## PINE VALLEY SUBDIVISION, SECOND ADDITION

APPLICATION	NUMBER	12	DATE _	June 16, 2005	N
APPLICANT Pine Valley Subdivision, Second Addition					\$
REQUEST	QUESTSubdivision				\
					NTS

## LOCATOR MAP

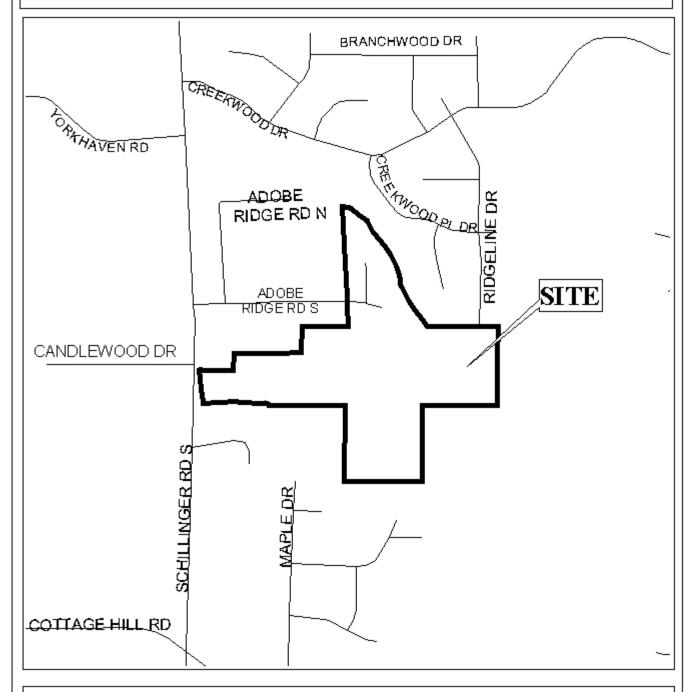
Schillinger Road, which has a variable right-of-way, is shown as a major street on the Major Street Plan, and as such requires a 100-foot right-of-way; therefore, the dedication of sufficient right-of-way to provide 50-feet from the centerline should be required. As proposed, Lot 1 would have frontage along Schillinger Road and Adobe Ridge Road South. This will allow for the site to be developed for a possible commercial use. Therefore, the placement of a note on the final plat stating that Lot 1 should be limited to two curb cuts to Schillinger Road, with the size, location and design to be approved by County Engineering, and that Lot 1 is denied access to Adobe Ridge Road South due to its potential commercial development and access to a residential neighborhood, should be required.

As indicated on the Vicinity Map, the site contains a creek and as such the area may be considered environmentally sensitive; therefore, the approval of any necessary federal, state and local agencies would be required.

This site is located in the County, thus a note should be placed on the final plat stating that any lots which are developed commercially and adjoin residentially developed property must provide a buffer, in compliance with Section V.A.7. of the Subdivision Regulations.

The required 25-foot minimum building setback lines are not shown, but would be required on the final plat.

With modifications, the plat will meet the minimum requirements of the Subdivision Regulations and is recommended for Tentative Approval subject to the following conditions: 1) the dedication of sufficient right-of-way to provide 50-feet from the

centerline of Schillinger Road; 2) the placement of a note on the final plat stating that Lot 1 is limited to two curb cuts to Schillinger Road, with the size, location and design to be approved by County Engineering; 3) the placement of a note on the final plat stating that Lot 1 is denied access to Adobe Ridge Road South; 4) the approval of all applicable federal, state and local agencies prior to the issuance of any permits; 5) the placement of a note on the final plat stating that any property that is developed commercially and adjoins residentially developed property shall provide a buffer, in compliance with Section V.A.7. of the Subdivision Regulations; and 6) the placement of the 25-foot minimum building setback lines on the final plat.
